Addendum #1

Date	Owner Property Number	Owner Building Number	BHDA Project Number
Fri, 21 Apr 2017	510-1409	1	1621

Project Designation	Project Address
Lakeridge 1, 4, 7 Remodel Orem UT Lakeridge Stake	158 East 1100 South Orem, Utah 84058

FLOOR FINISHES PLANS

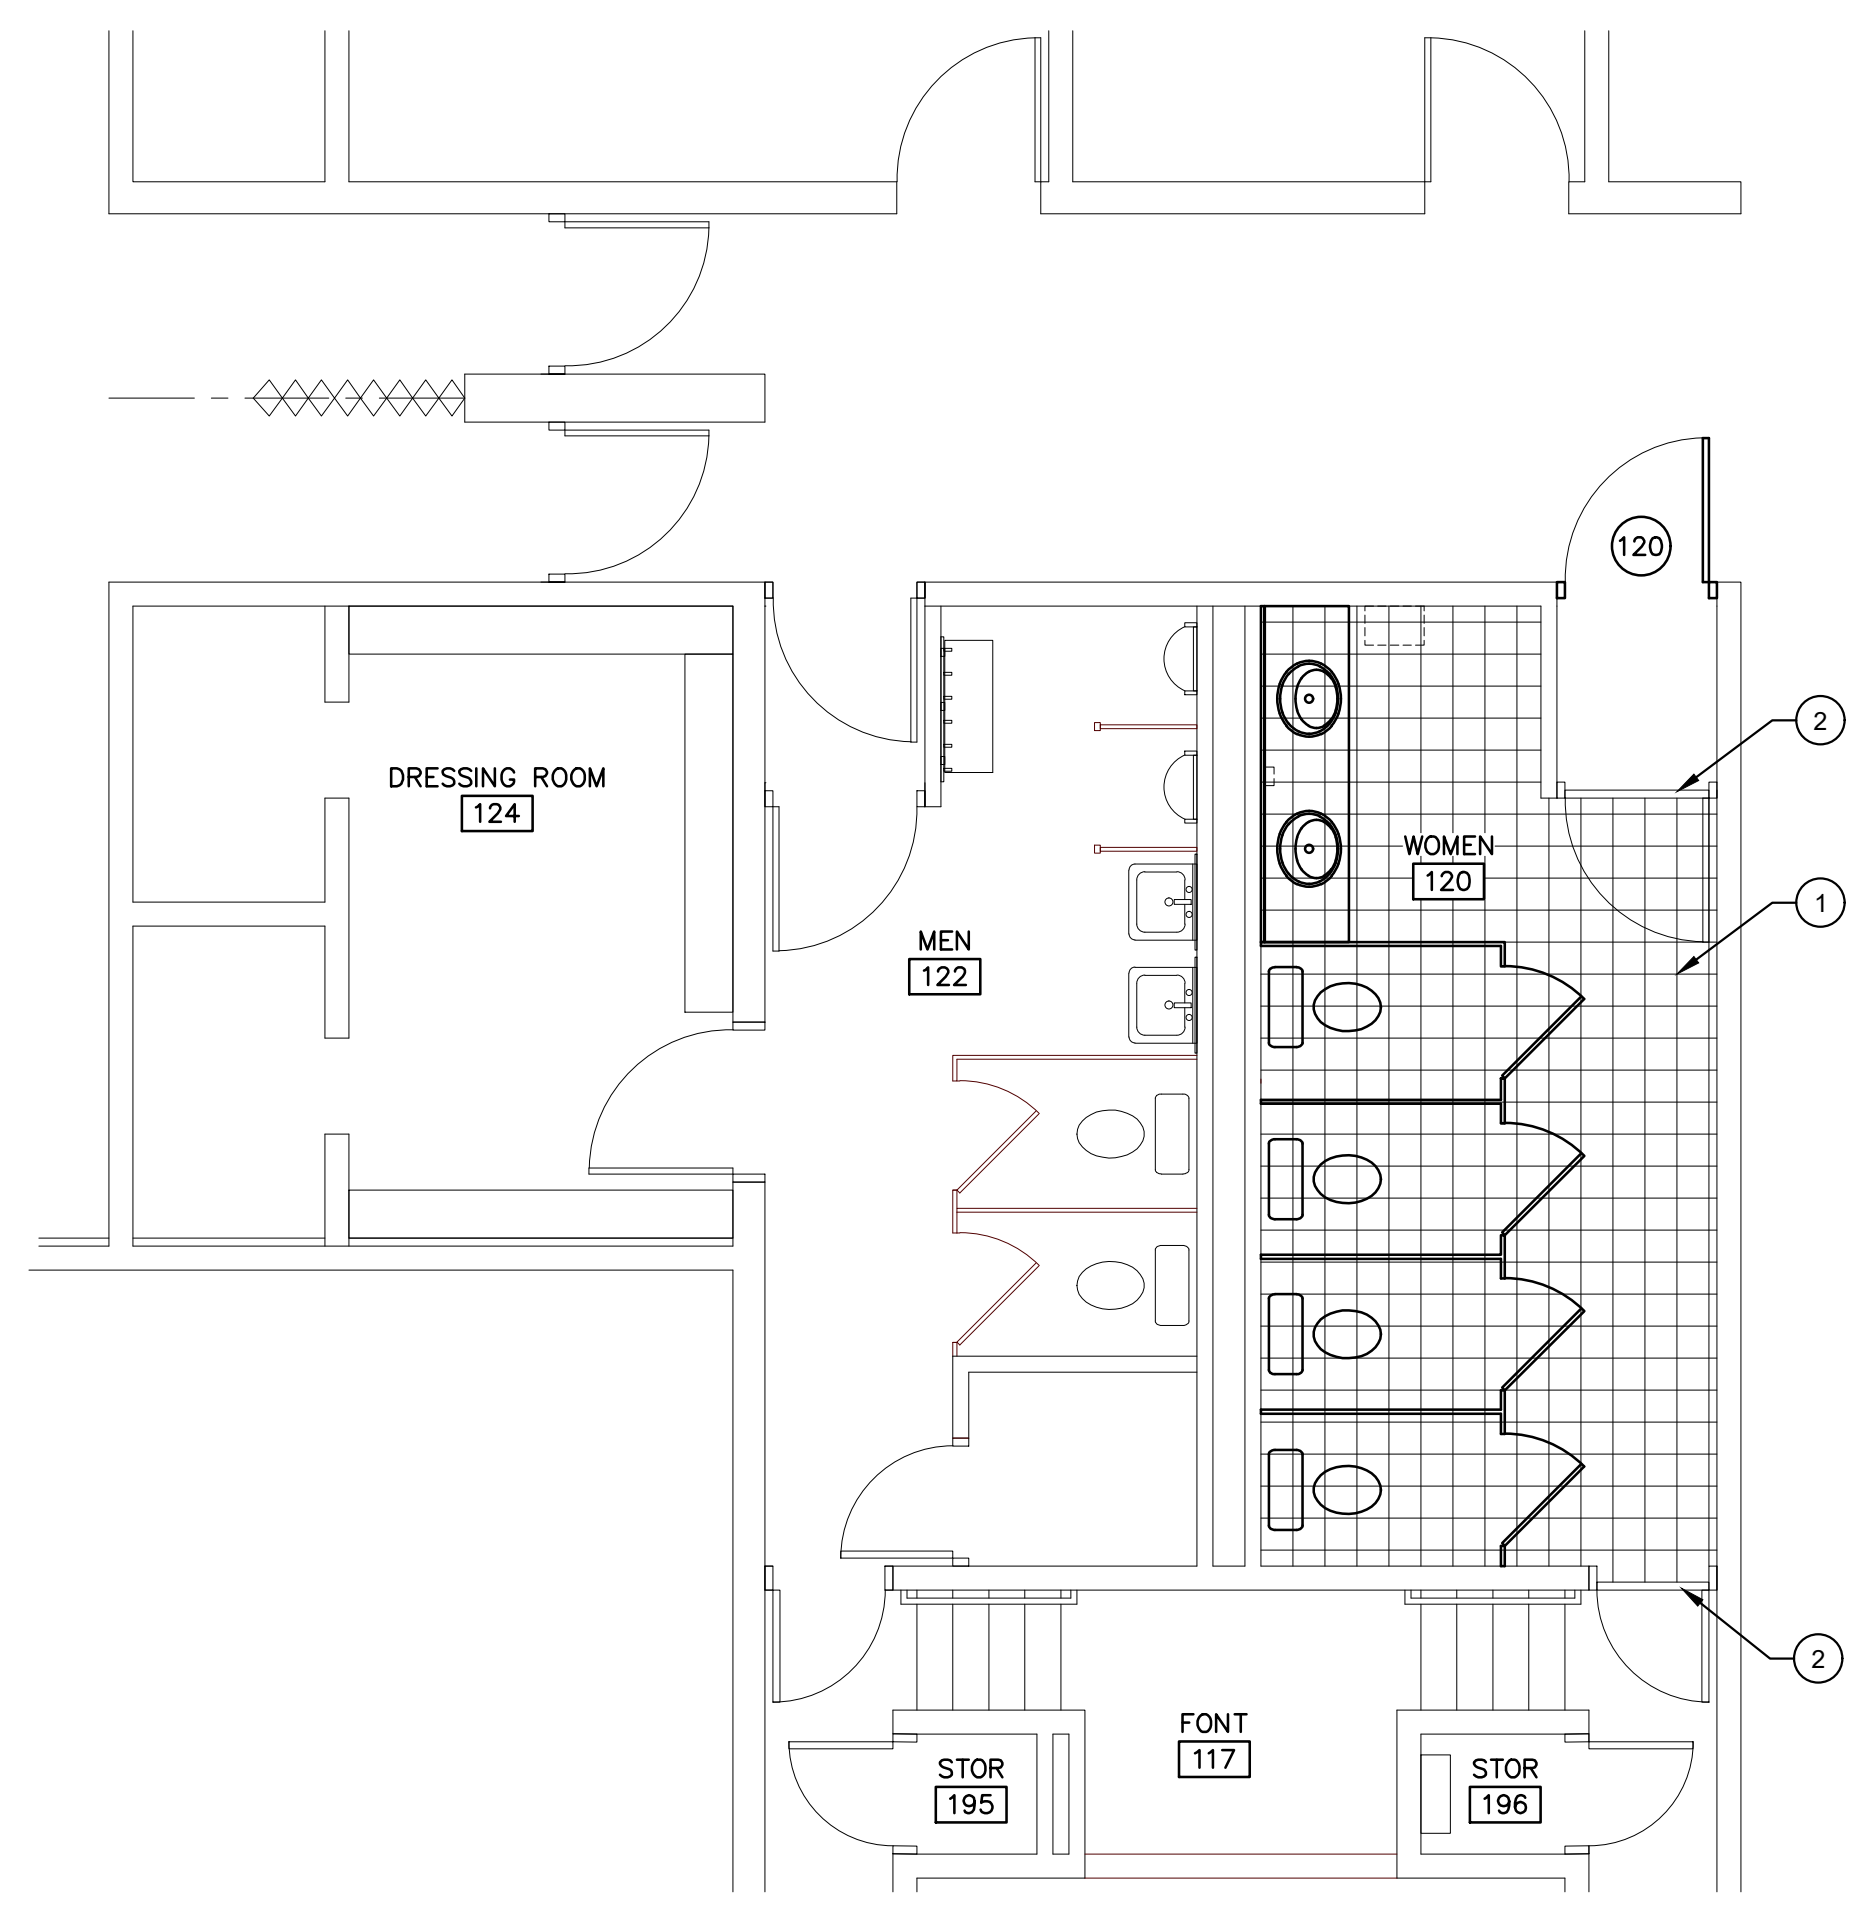
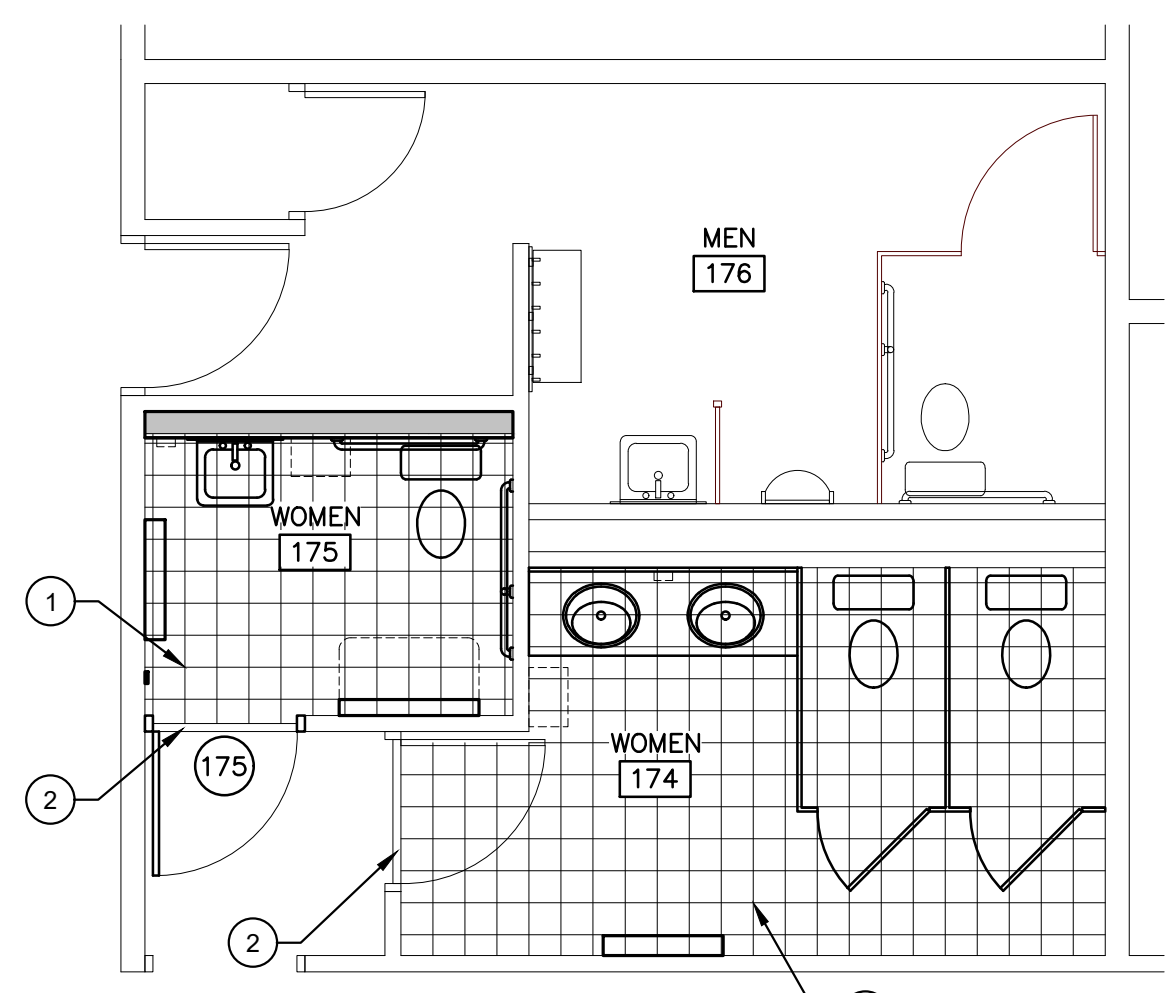
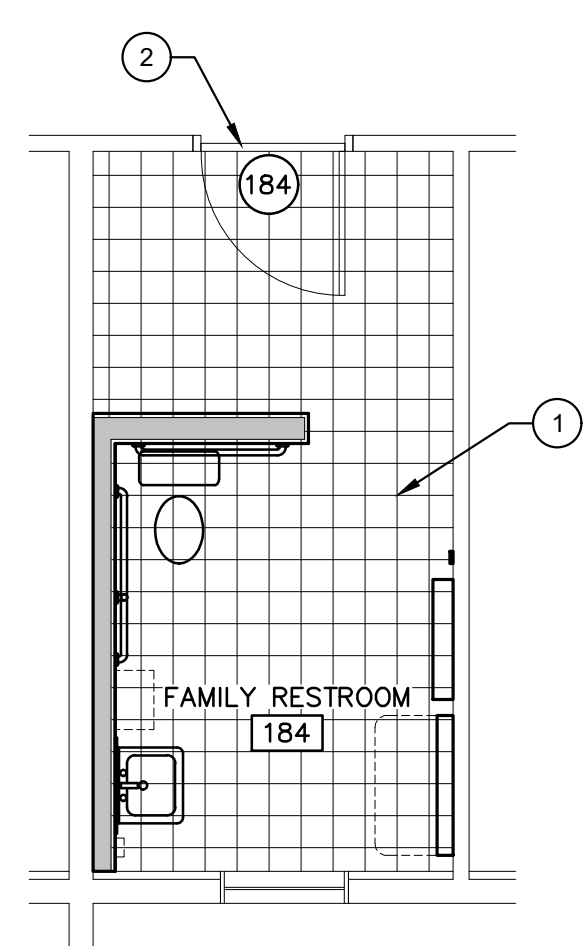
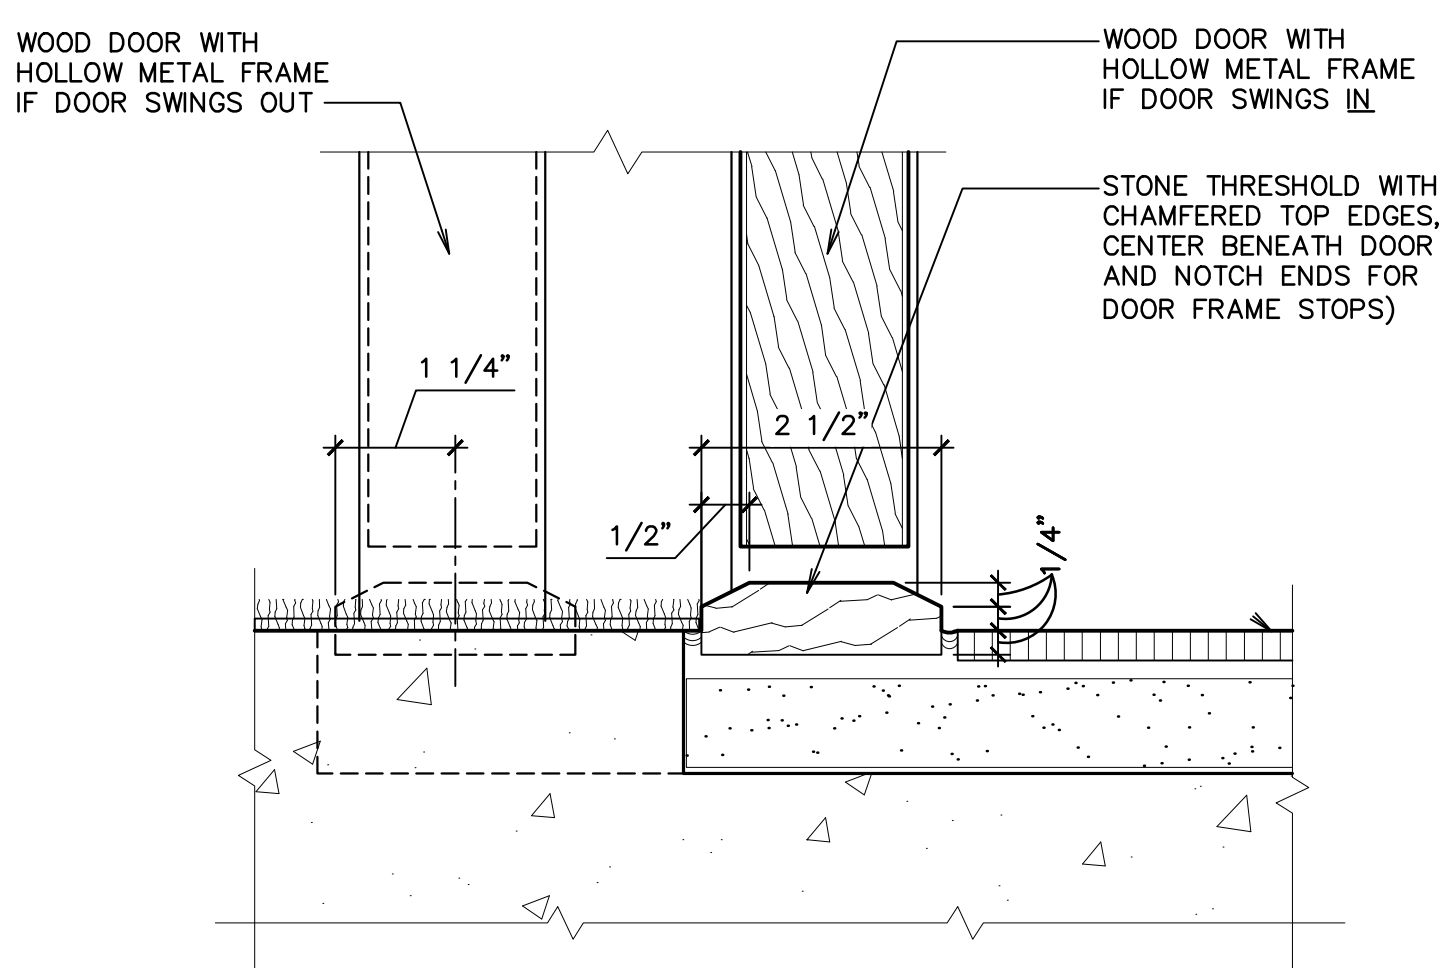
4.02. Sheet F101 Floor Finishes Plans

- A. Replace this sheet with the attached revised Sheet F101.
 - 1. Added missing Keyed Notes.
-
